**ADDENDUM NO. 2**

**DATE:** October 30, 2018  
**FROM:** City of Grand Junction Purchasing Division  
**TO:** All Offerors  
**RE:** Kannah Creek Intake and/or Purdy Mesa Flowline Rehabilitation IFB-4568-18-DH

SHEET NO. C2-505
REVISION 6

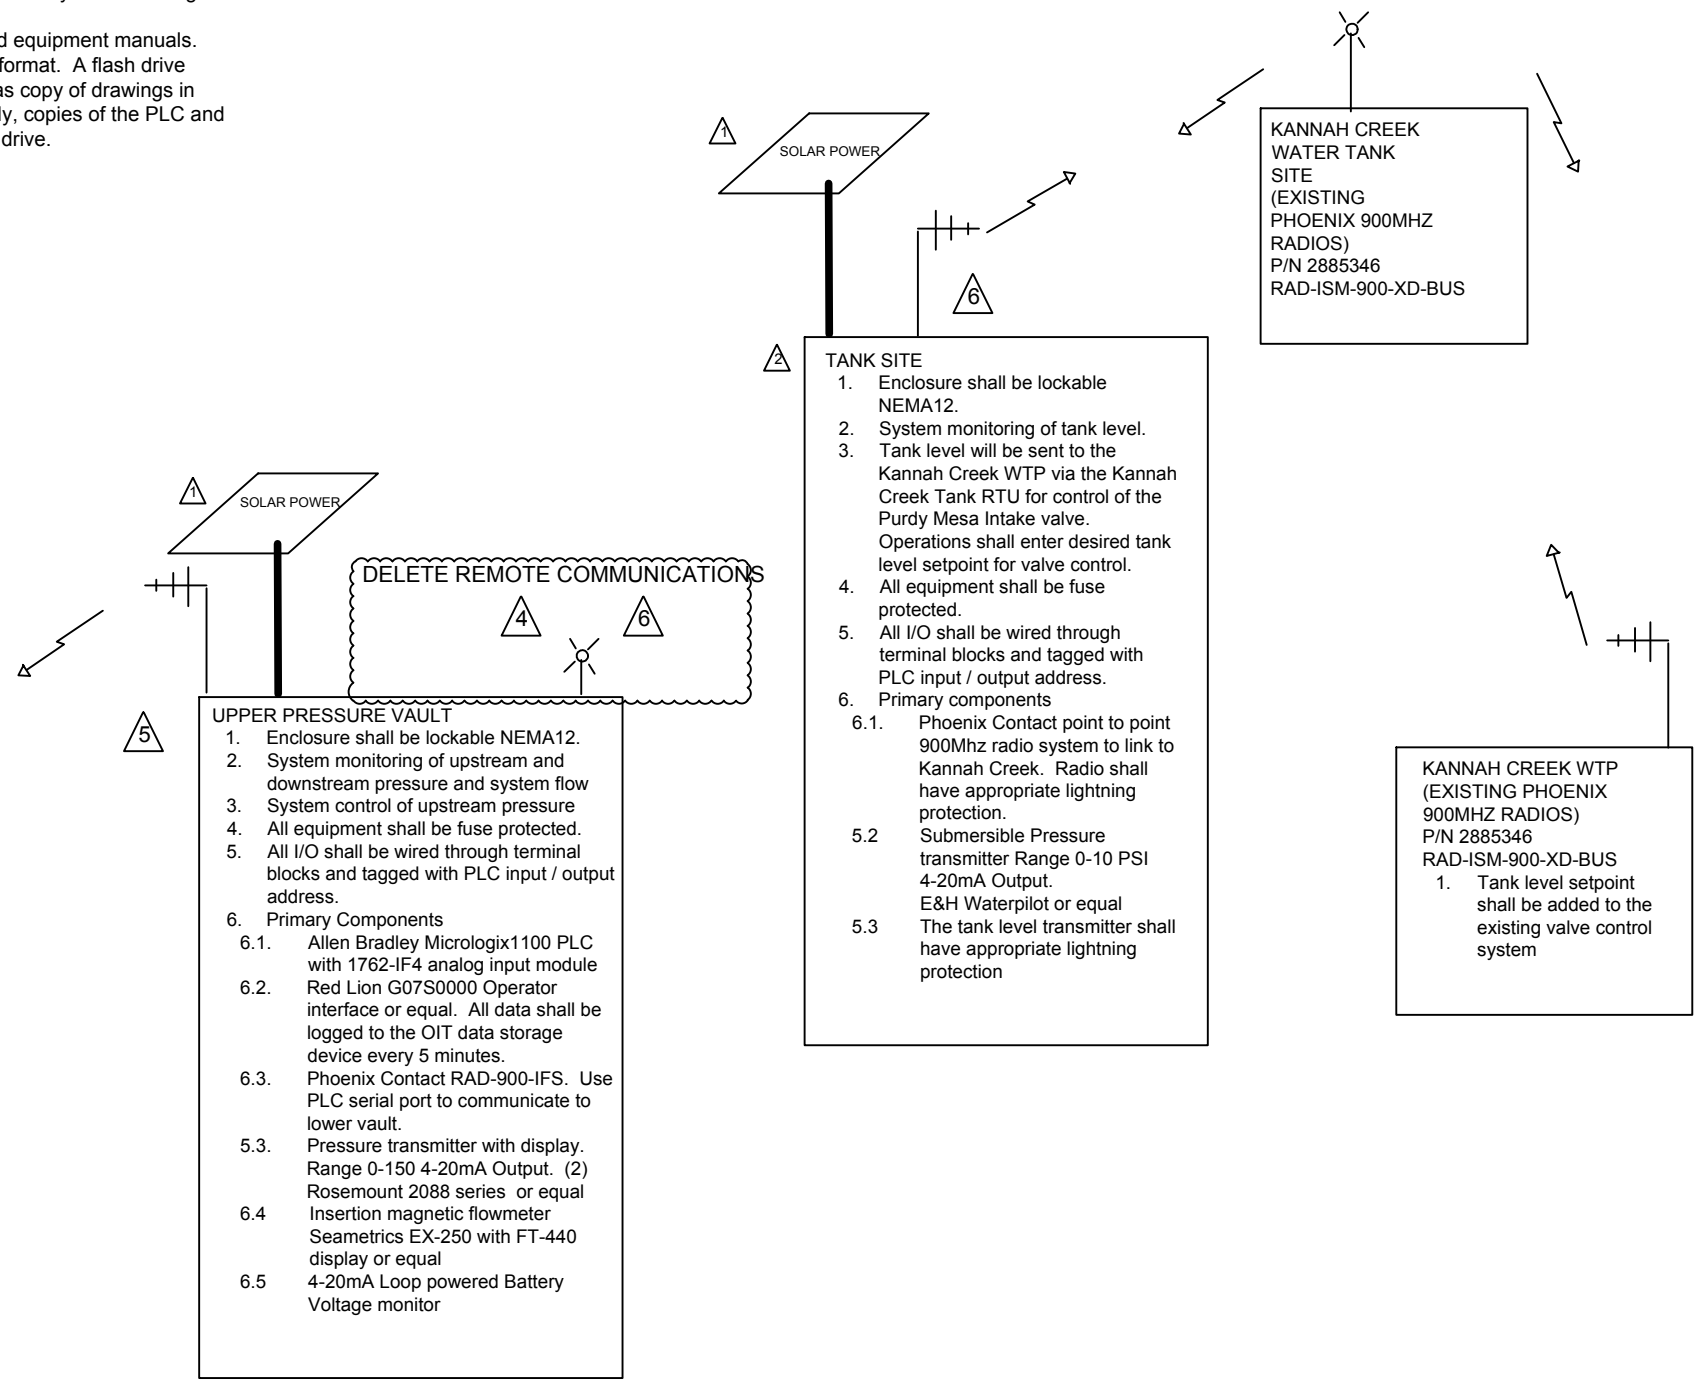
8. Revised SCADA Plan Sheet C2-505 is attached as Exhibit E (one page).

- 4) ~~The flow vault will be the primary pressure control site for the pipeline. Communications to this site will be via cellular modem. The modem will need additional security to prevent access from networks outside of the water treatment plant (Tosibox 500 or equivalent)~~

**DELETE WTP SITE WORK FROM SCOPE**

1. ~~Monitor and control the flow vault site via IP address link~~
2. ~~Monitor the new tank level via existing remote connection to Kannah Creek~~
3. ~~Add new control panel in main flow control vault to monitor and control new pressure sustaining valve.~~
4. ~~All equipment will be fuse protected.~~
5. ~~Panel will need ethernet link to WTP control room and wiring from new vault to panel.~~
6. **Primary Components**
  - 6.1. ~~Allen Bradley Micrologix1100 PLC with 1762-IF4 analog input module~~
  - 6.2. ~~Red Lion G07S0000 Operator interface or equal. All data shall be logged to the OIT data storage device every 5 minutes.~~
  - 6.3. ~~Pressure transmitter with display. Range 0-150 PSI 4-20mA Output. (2) Rosemount 2088 series or equal~~
  - 6.4.

- 2) Purdy Mesa Tank site will send the tank level signal to the existing Kannah Creek WTP site via the Kannah Creek Tank site. Integrator will add the Purdy Mesa tank level signal and associated high / low alarms to the Kannah Creek SCADA system.

1. Tank level setpoint shall be added to the existing valve control system
